PLANNING AND DEVELOPMENT SERVICES STAFF REPORT

For Planning Commission Meeting of March 19, 2013

**SUBJECT: State Street Center Site Plan for City Council Approval
(3945 South State Street)
File No. SP12- 027**

Sheet Title
 SITE PLAN

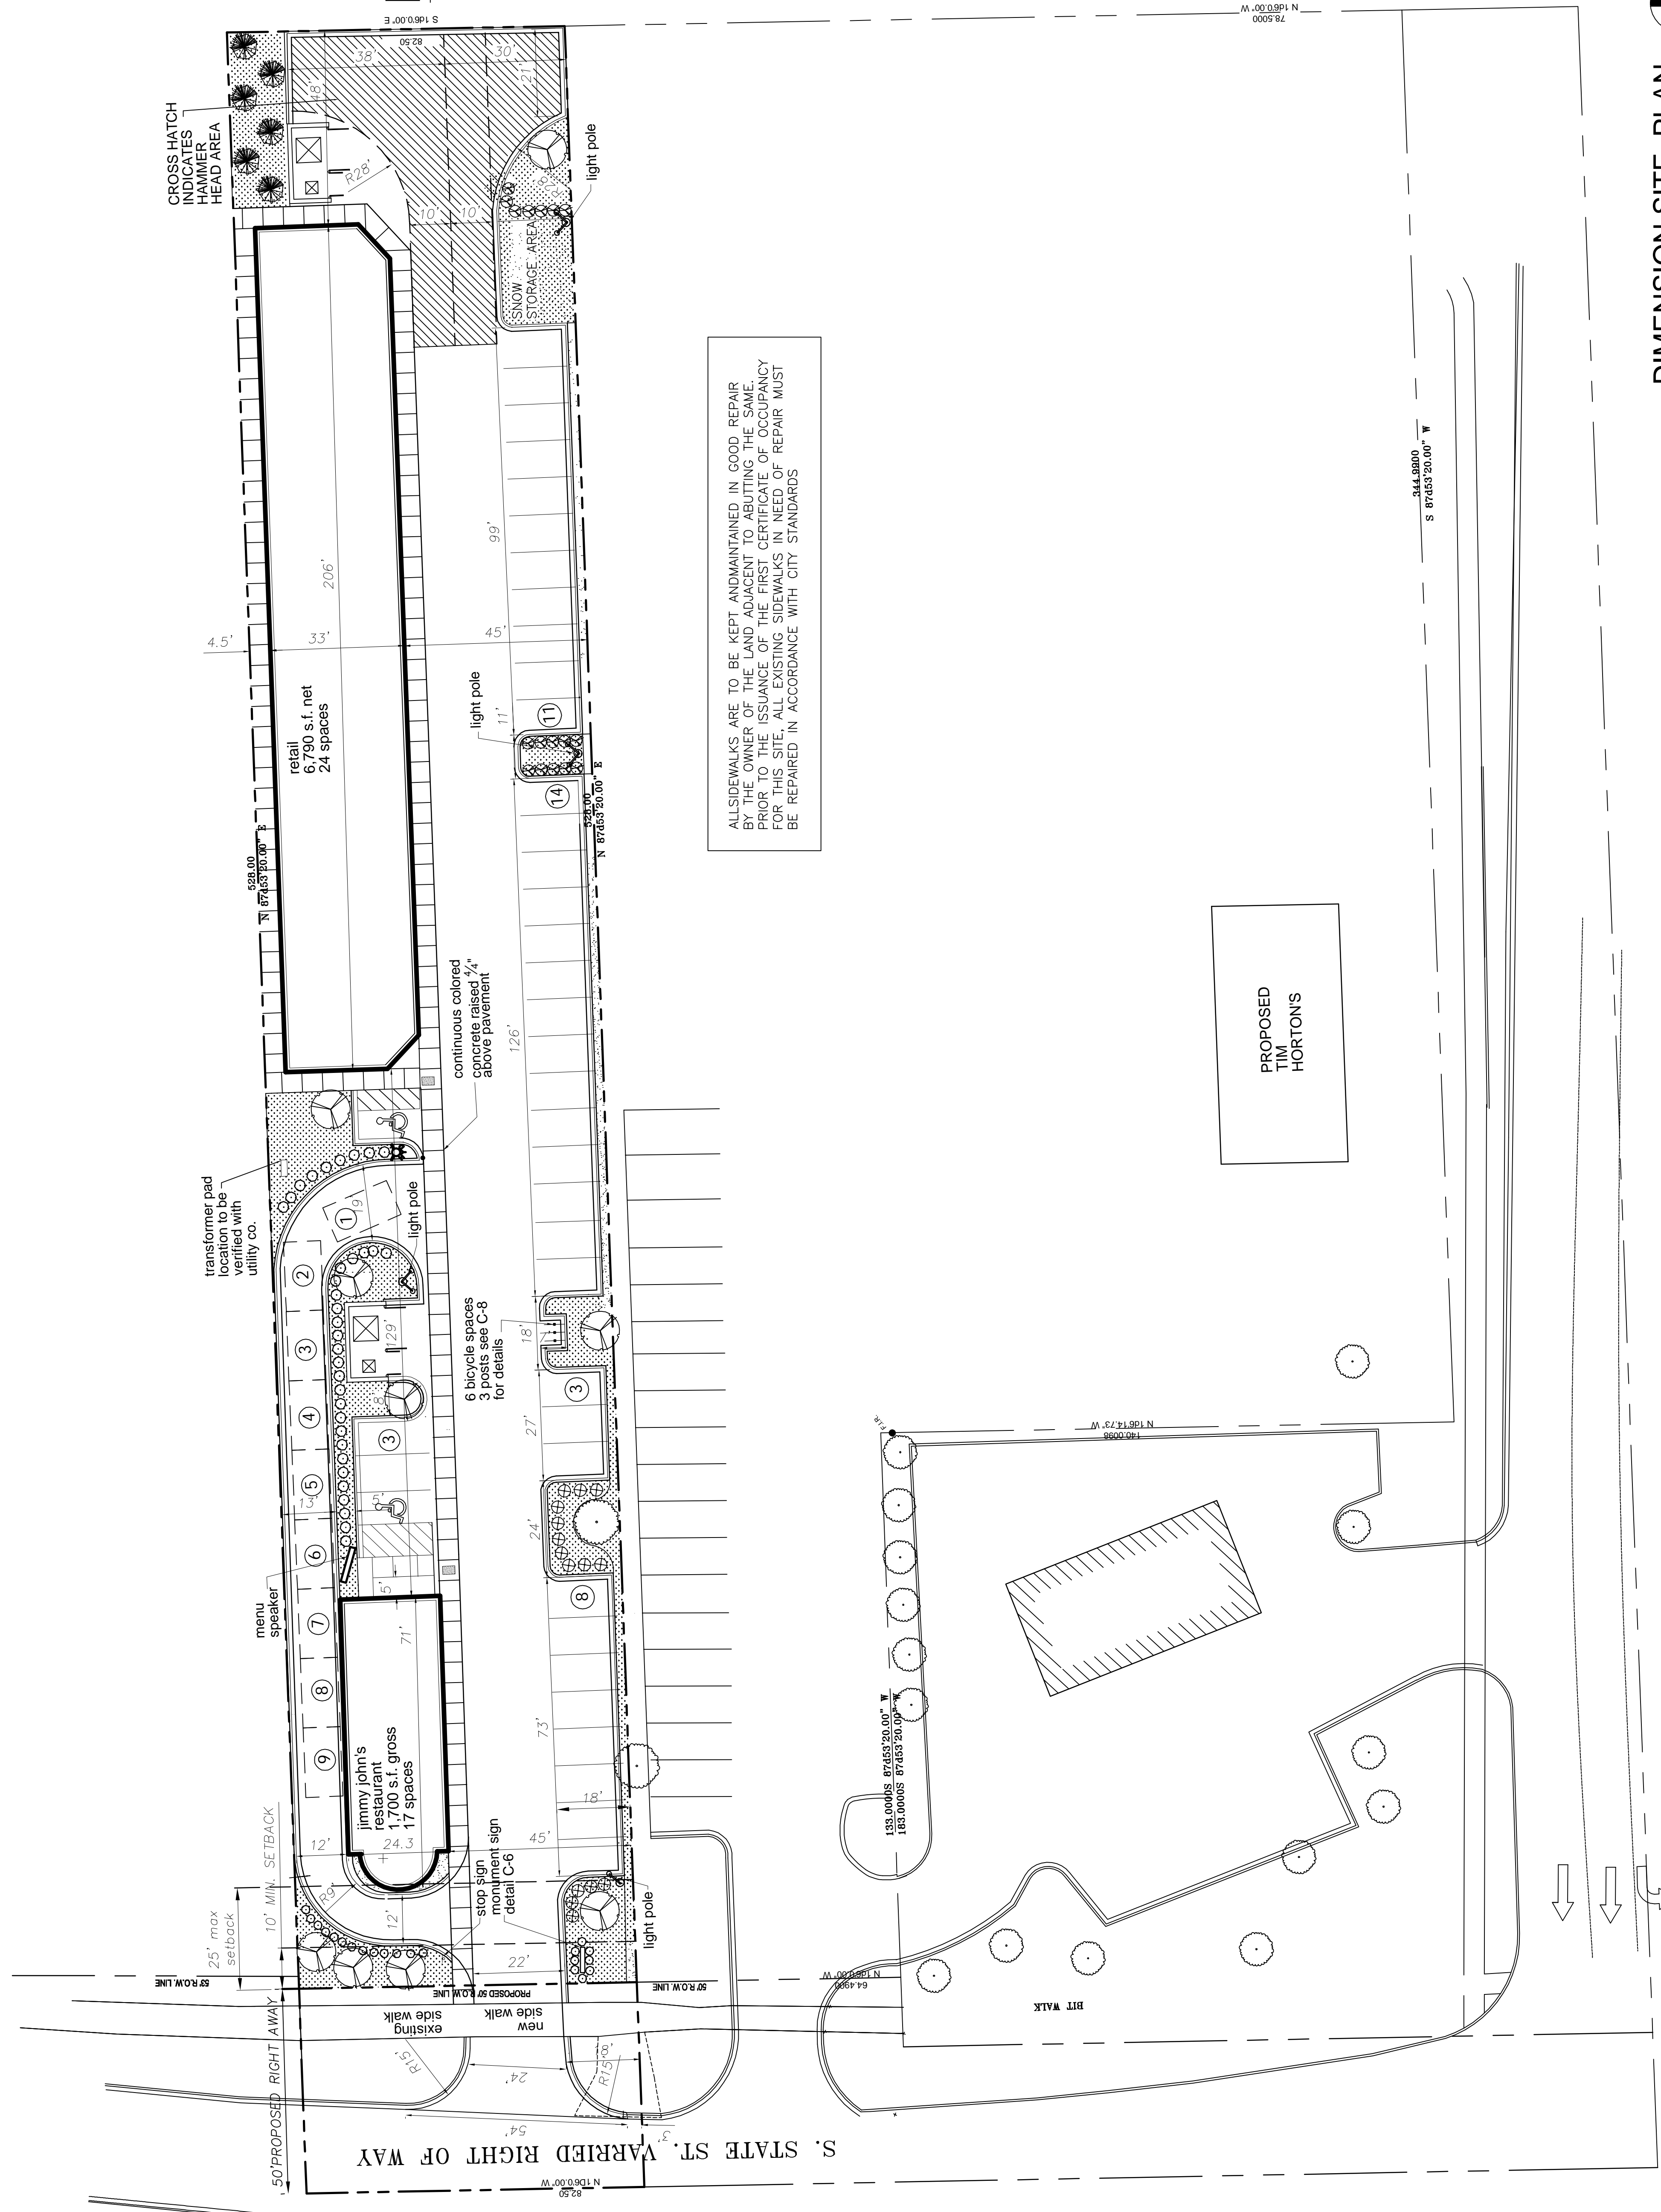
Systems Planning – One footing drain disconnection is required to mitigate sanitary flow as part of this development.

The South State Street right-of-way (total 50 feet) shall be dedicated to the City prior to the issuance of any permits.

Storm Water – The proposed permeable pavement is appropriate for drainage of this site, as sandy soils exist in the area. Maintenance of the parking lot must be performed twice per year for the lot to function and drain properly as porous pavement.

Chapter 63, Section 5:655(4) states that the detention facility shall be installed prior to issuance of building permits. However, it is not practical to construct the porous paving before the buildings are constructed. Therefore, the design includes a temporary sedimentation basin that will remain in service through construction, until the porous pavement is completed.

Planning – During review of the proposed site plan, staff discovered this site is not zoned C3, Fringe Commercial, as shown in the City's zoning maps. This site is currently zoned Office, which does not permit the proposed retail and drive-thru uses. Because this zoning error was discovered late in the review process, the petitioner did not have sufficient time to apply for a rezoning request to C3 before being heard at the upcoming City Planning Commission meeting. Once the petitioner submits the rezoning application, staff will review this application and place it on the next possible Planning Commission agenda.
